## **Proposal for Supplement 17 to the 00 series of amendments to Regulation No. 4 (REAR REGISTRATION PLATE LAMPS)**

Note: The modifications to the current text of the UN regulation are marked in bold for new or strikethrough for deleted characters.

- (e) **devices for illuminating a plate of Category 5 (440 x 220 mm)**

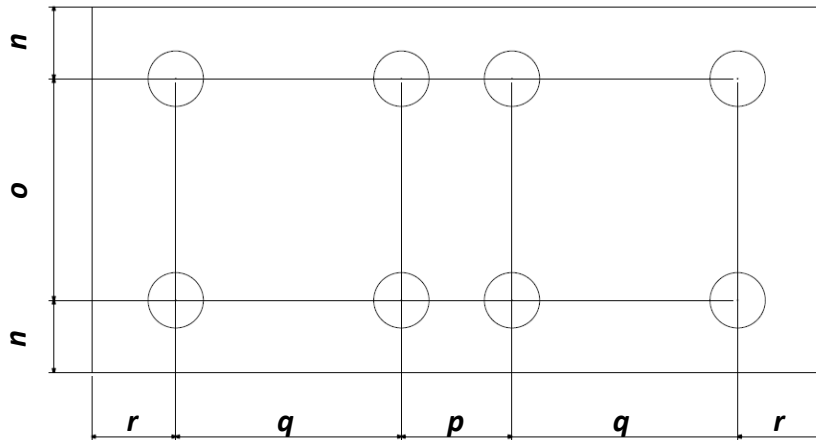
$n = 50 \text{ mm}, o = 120 \text{ mm}, p = 50 \text{ mm}, q = 145 \text{ mm}, r = 50 \text{ mm}$
